## **ADDENDUM NO. THREE (3) ILM TERMINAL IMPROVEMENTS CONTRACT 3**

Date: July 30, 2019

RE: ILM Terminal Improvements Contract 3

From: The Wilson Group  
PO Box 5510  
Charlotte, NC 28299

## SCHEDULE 2 - TICKET LEVEL FLOOR PLAN ZONE 4

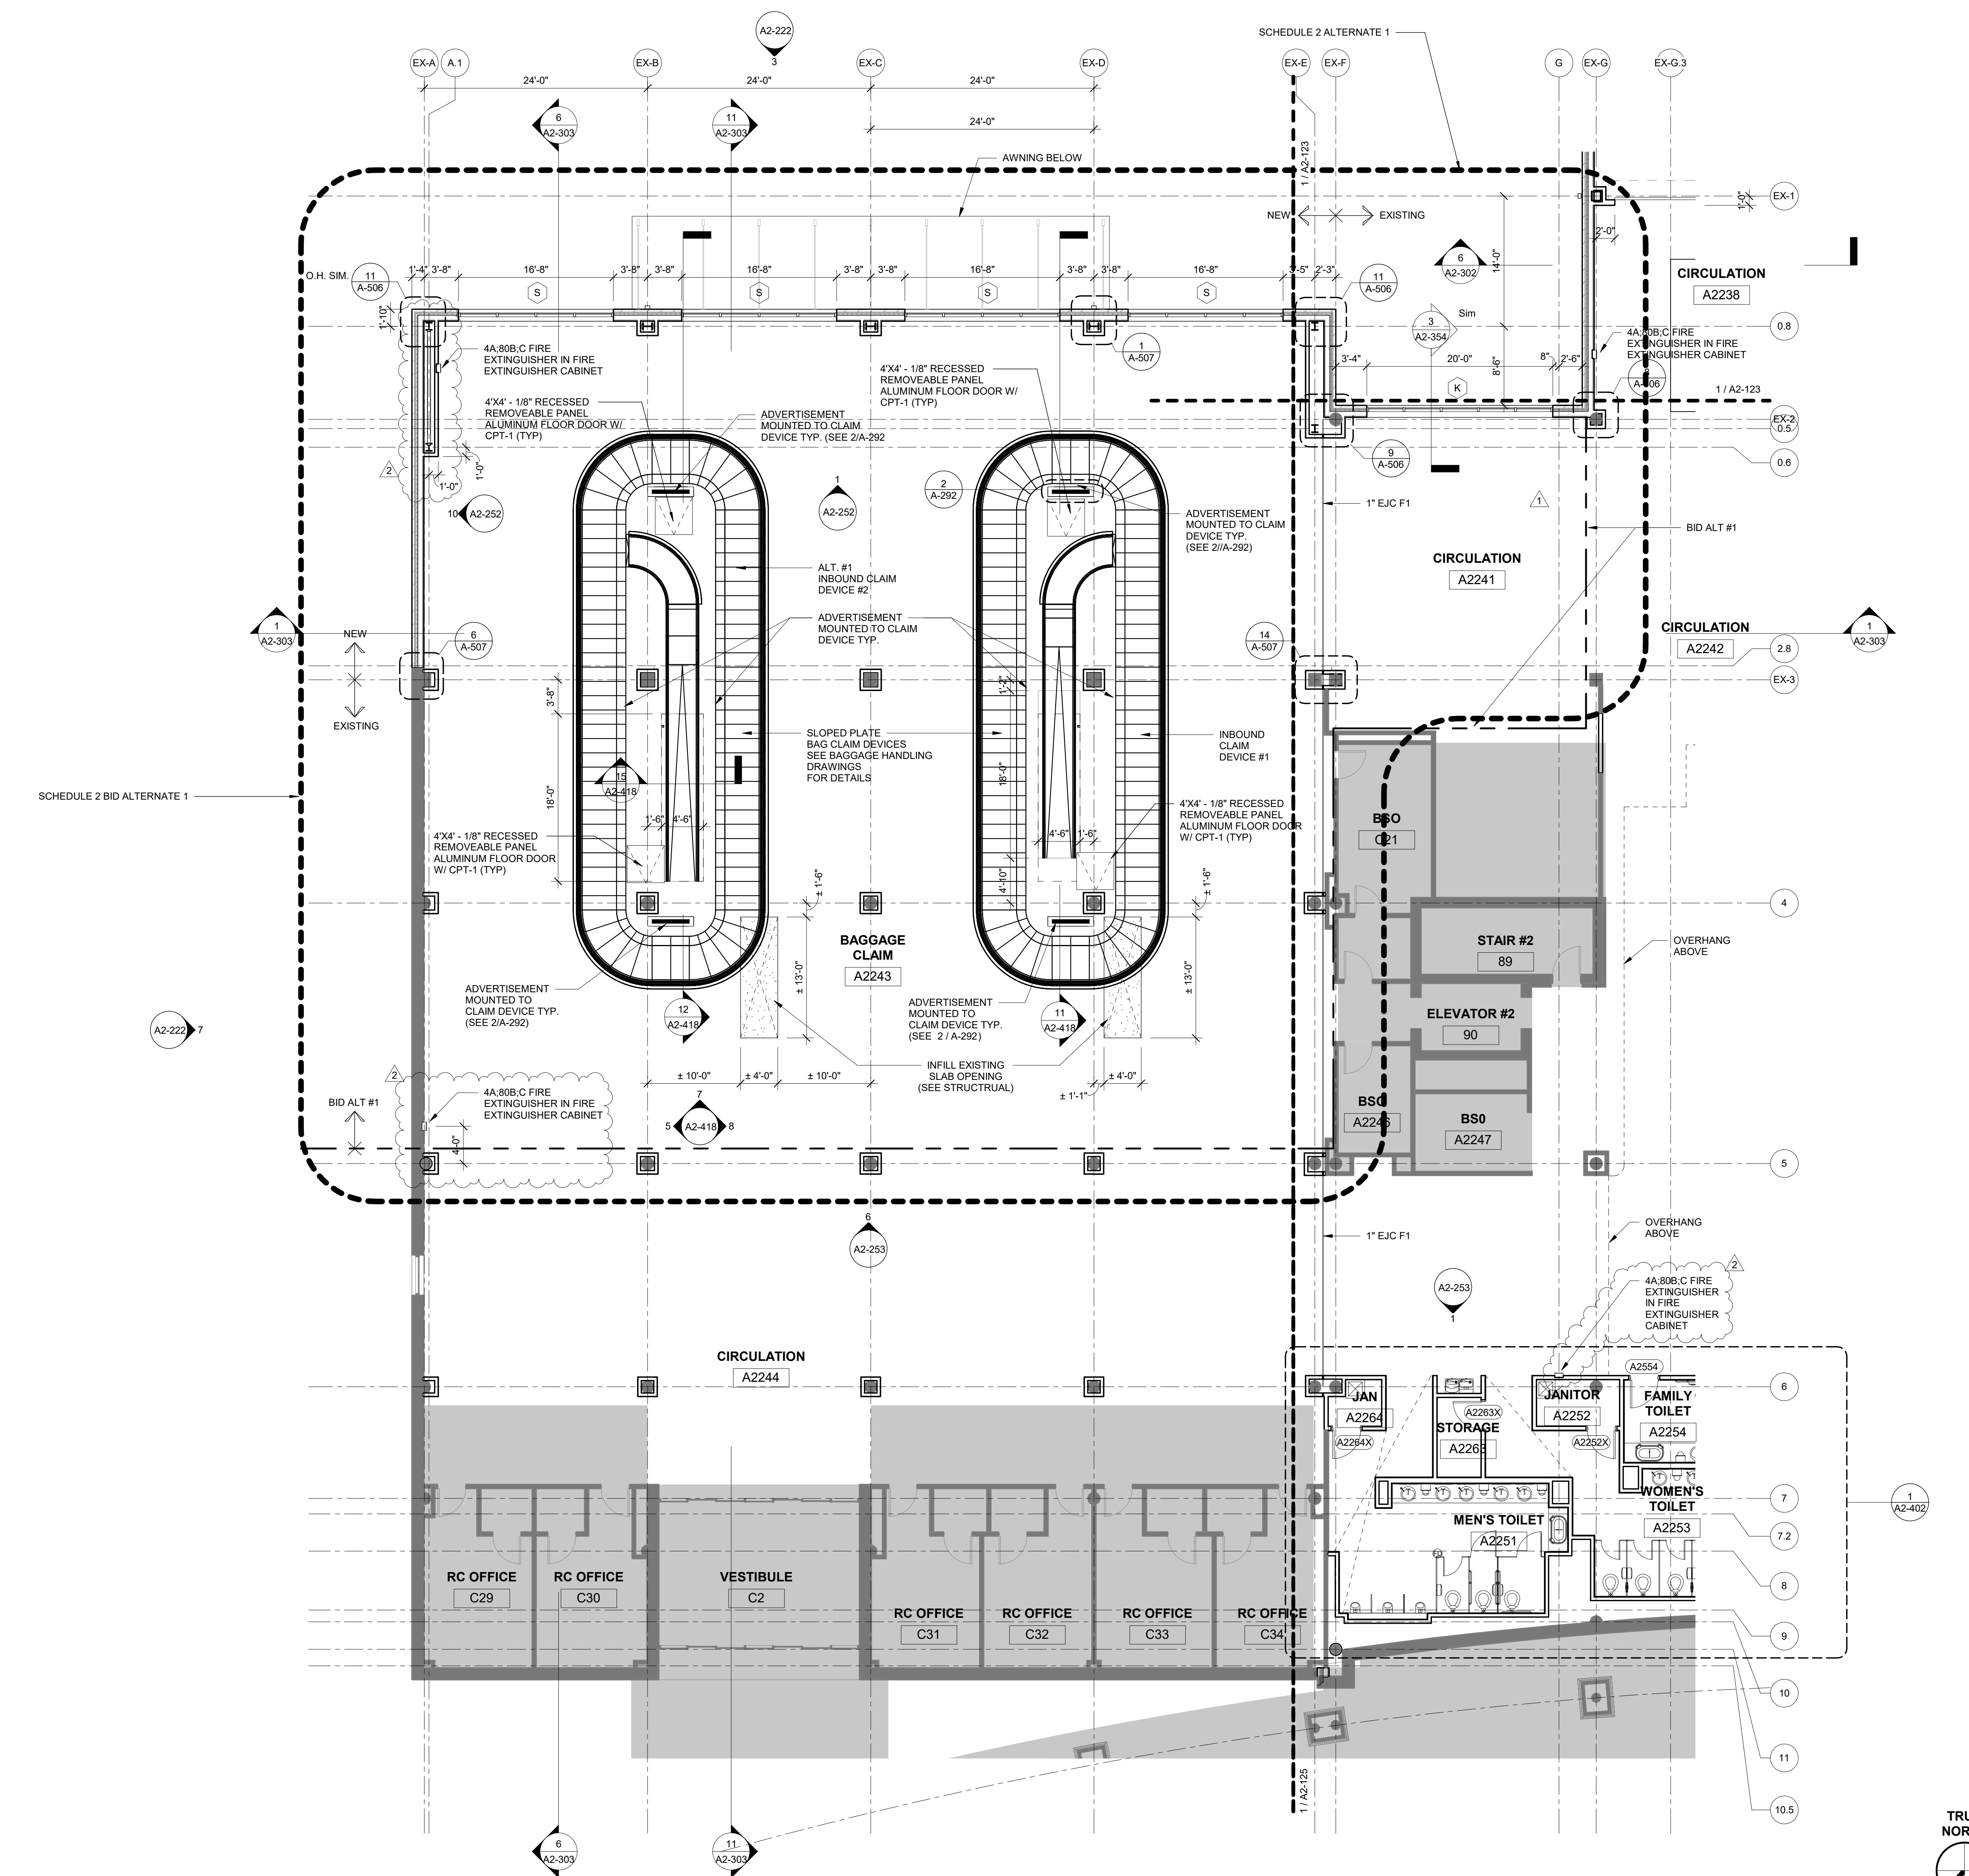
- ddd. A2-121 SCHEDULE 2 – BOARDING LEVEL FLOOR PLAN ZONE 1 (AD-03). *Note: Added roof access hatch and ladder.*
- eee. A2-124 SCHEDULE 2 – TICKET LEVEL FLOOR PLAN ZONE 4 (AD-03). *Note: Adjusted wall bump-out along Column Line A.*

## SCHEDULE 2 - TICKET LEVEL FLOOR PLAN ZONE 5

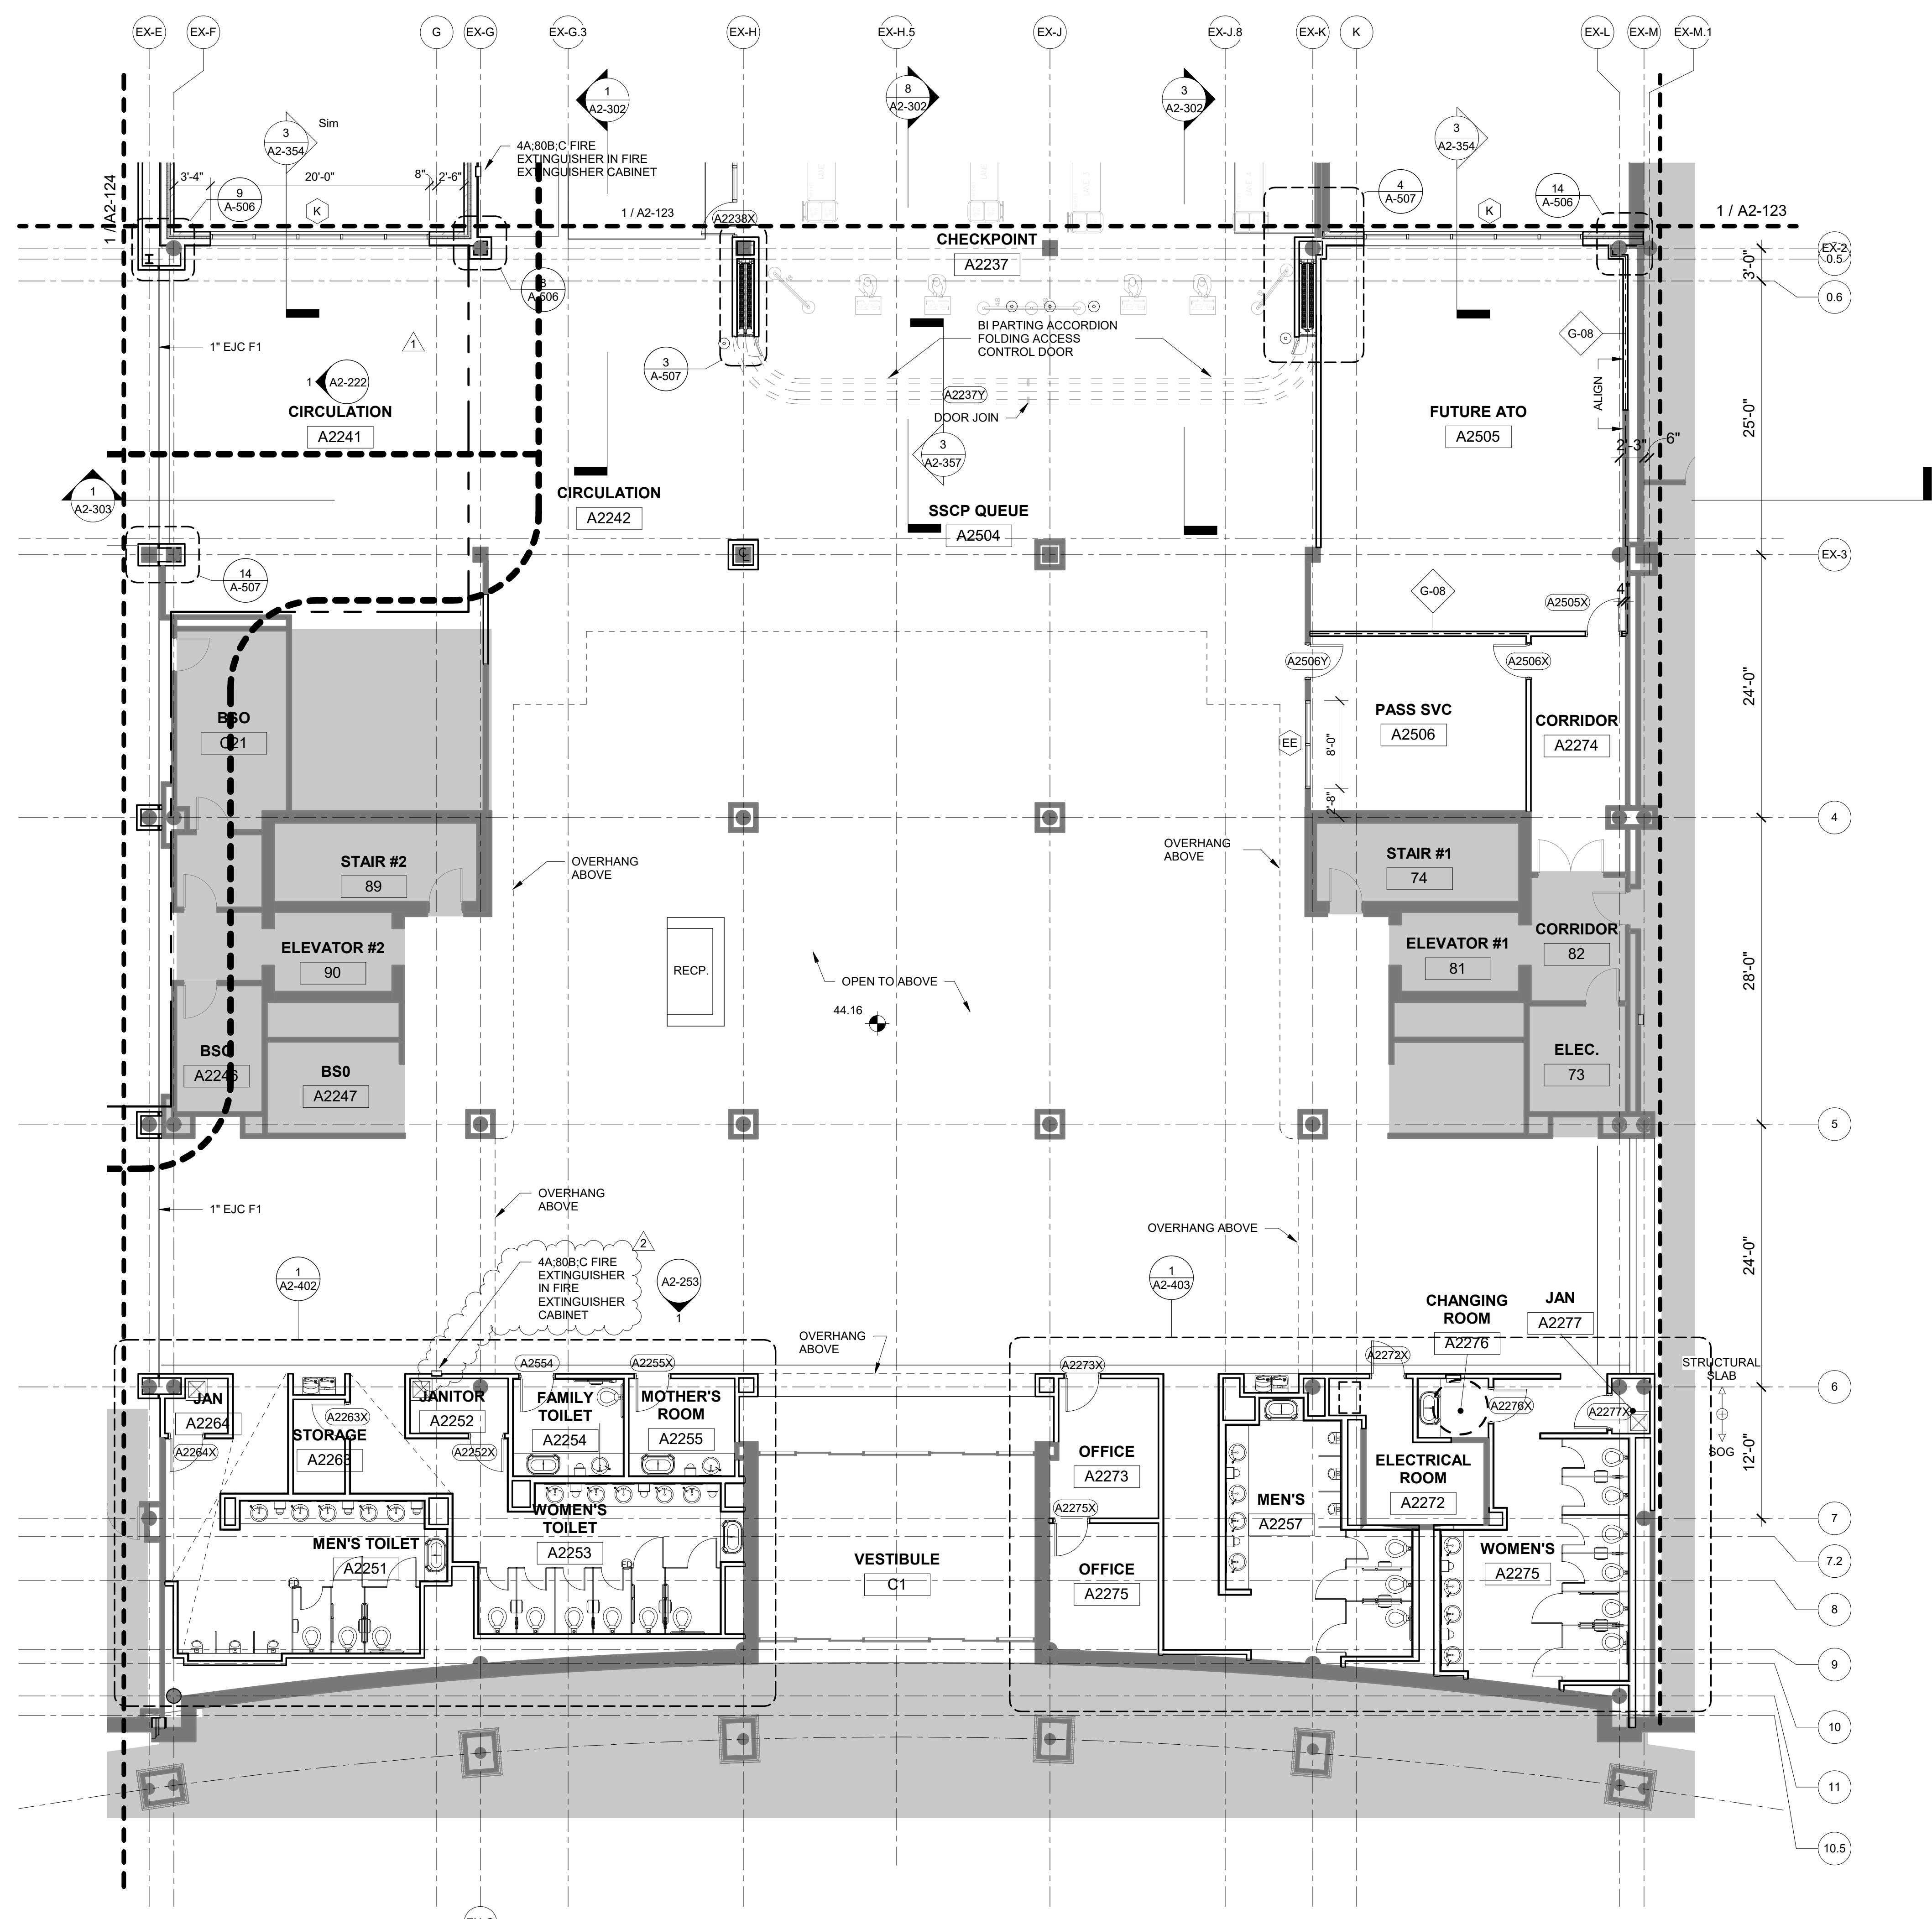
- fff. A2-125 SCHEDULE 2 – TICKET LEVEL FLOOR PLAN ZONE 5 (AD-03). *Note: Added fire extinguisher cabinet.*
- ggg. A2-141 SCHEDULE 2 – ROOF LEVEL PLAN ZONE 1 (AD-03). *Note: Added roof access hatch.*

SHEET NUMBER  
**A2-143**

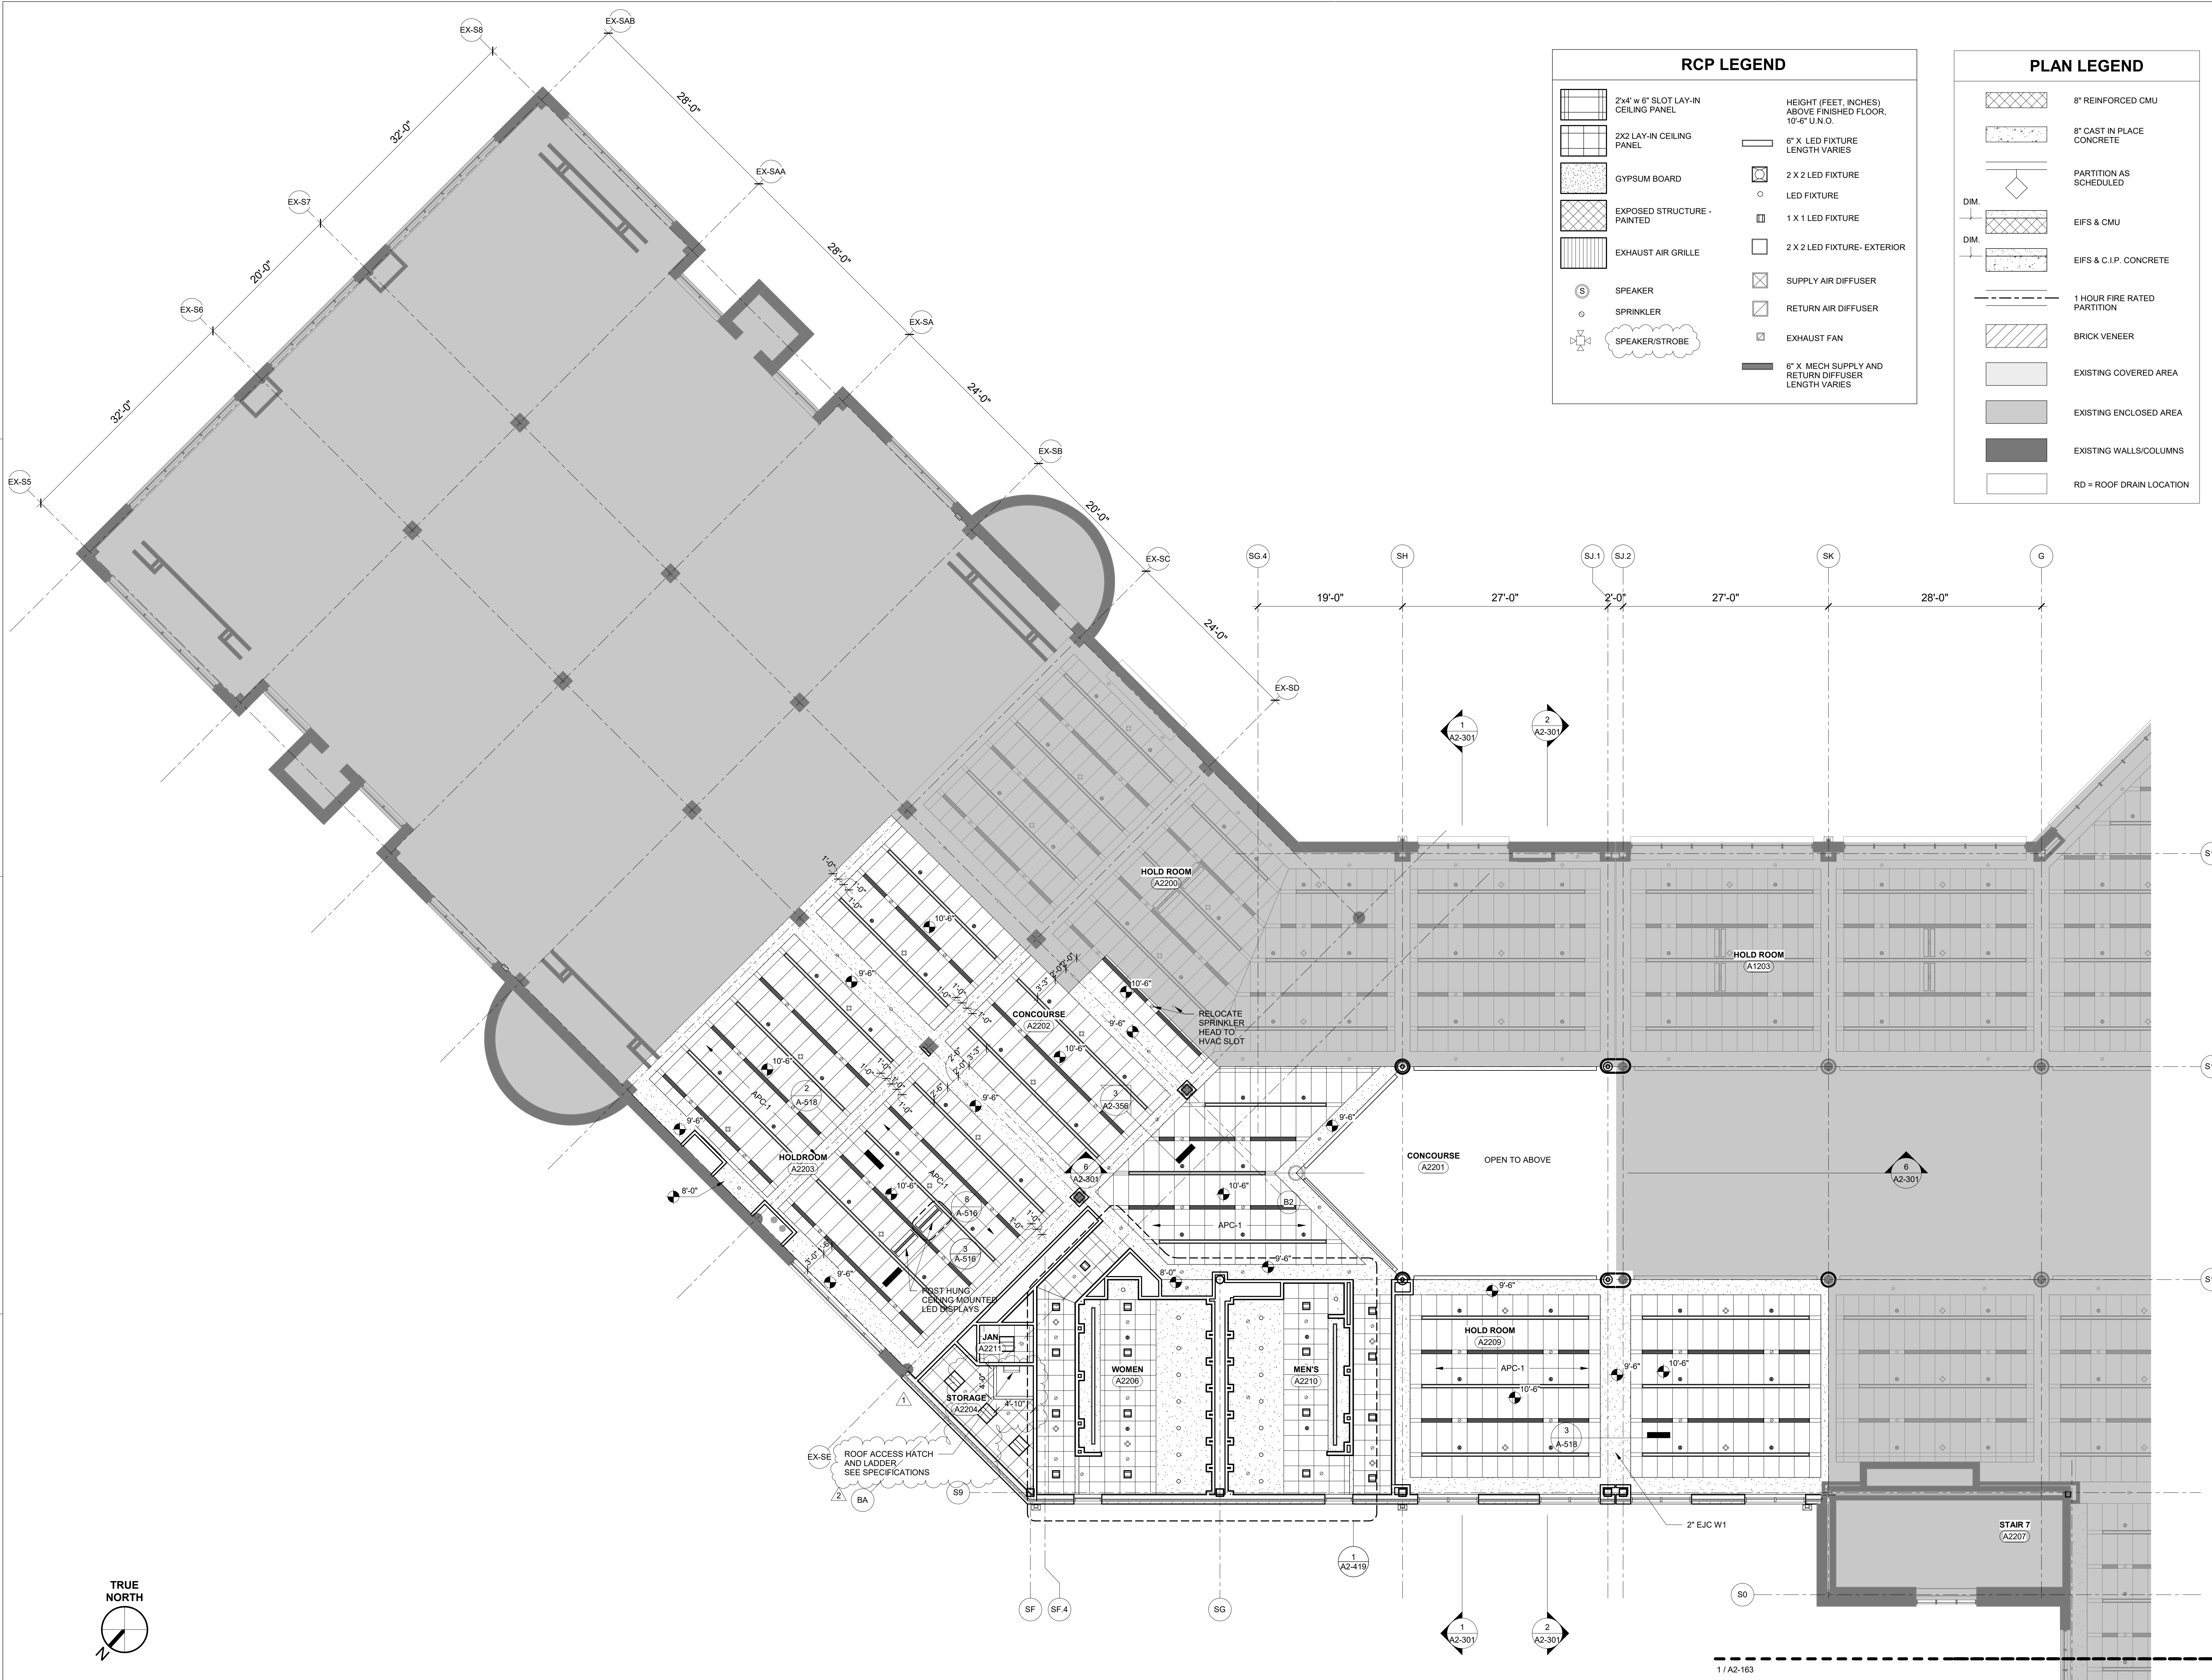
- hhh. A2-143 SCHEDULE 2 – ROOF LEVEL PLAN ZONE 3 (AD-03). *Note: Added roof drainage area tags.*
- iii. A2-161 SCHEDULE 2 – BOARDING LEVEL RCP ZONE 1 (AD-03). *Note: Added roof access hatch.*
